**INVITATION TO TENDER NO. PS20180920  
PROVISION OF CONTRACTOR SERVICES FOR WASHROOM UPGRADES  
AT 3214 W 10 AVE**

**ADDENDUM NO. 3**

**RE: ARCHITECTURAL/MECHANICAL DRAWINGS & SPECIFICATIONS**

#### ***CURB OPENING (AIR HANDLING UNITS)***

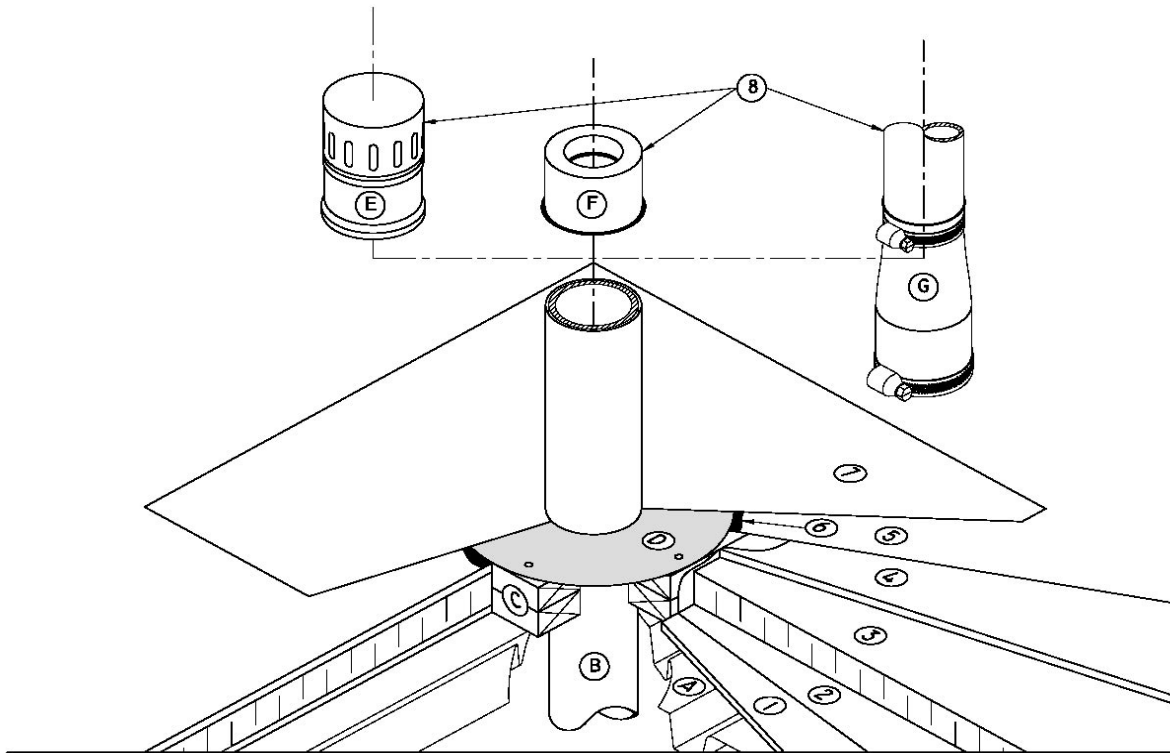
1. RGC Roofing Practices Manual - Updated 00-01-25; Rev 2; Tab 8.3.5; Page 1  
8.3.5 Curbs, Penetrations and Openings: Curb Opening (Air Handling Units)  
(attached)
2. RGC Roofing Practices Manual - Updated 06-01-30; Rev 1; Tab 8.3.5; Page 5  
8.3.5 Curbs, Penetrations and Openings: Metal Plumbing Flashing (attached)

- (1) **Gypsum Overlay Board:** If required by design authority.
- (2) **Vapour Retarder:** If required by design authority.
- (3) **Insulation:** See list of accepted materials in Tab 2.2.
- (4) **Insulation Overlay:** Where required. See *RGC Guarantee Standard B4.1, B4.2 and C4.1*
- (5) **Primary Membrane and Membrane Protection**
- (6) **Membrane Flashing:** Lap one ply over top of each side of curb (C) and mechanically fasten.
- (7) **Metal Base Flashing:** Mechanically fastened. Standing seam at corners of cant.

- (A) **Acceptable Deck**
- (B) **Air / Vapour Seal**
- (C) **Wood Curb / Blocking:** Minimum 200 mm (8") and maximum 300 mm (12") above finished roof surface.
